**Subject: Recommendation for Lake Lowering, Ida Lake Dam Structural Inspection,
NYS ID: 226-1391**

Chris Wheland, Superintendent of Public Utilities
Ida Lake Dam Rehabilitation Project – Structural Inspection of Timber Spillway

FIGURE 1 - TYPICAL CROSSWISE SUPPORTING STRUCTURE (BENT)

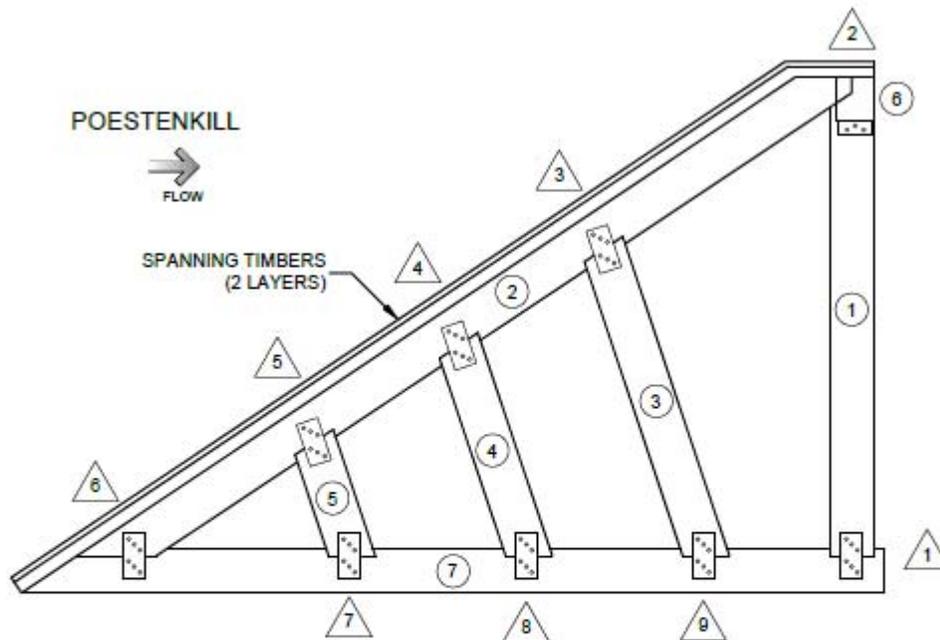
There are 28 bents set across the Poestenskill Creek creating a 135-ft long spillway comprised of 27 bays numbered F-1 through F-27. The inspection of the timber spillway structure involved entering behind the nappe of the spillway flow and systematically moving through each bay to evaluate the condition of the timbers that comprise the bents and the first layer of spanning timbers exposed within each bay. In general, the large 10-inch by 12-inch supporting timbers (6 members per bent) used to construct the bents are in fair to good condition. The 4-inch by 8-inch spanning timbers are in fair to very poor condition. The condition of the spanning timbers is most severe near the center of the spillway in Bays F-13 and F-14 where they are undergoing failure as evidenced by excessive deflection likely due to prolonged center channel debris/ice impact and subsequent timber decay. In addition to the observed spanning timber distress there is excessive leakage through spanning timbers in both Bays F-13 and F-14 as well as adjacent bays.

It is Schnabel's opinion that structural failure of spanning timbers will progress over the next 12 months within Bays F-13 and F-14, likely leading to a dam breach similar to the Ida Lake Dam failure that occurred in January 1999. An illustration of the 1999 breach is shown on Figure 2.

To prevent another breach, we recommend taking emergency preemptive measures to lower the Ida Lake Pool level to minimize/eliminate the stresses on the dam. No mechanical means presently exist to implement this lake lowering; therefore, it would need to be accomplished by contractor intervention likely resulting in the full or partial removal of the most deteriorated Bays F-12 through F-16.
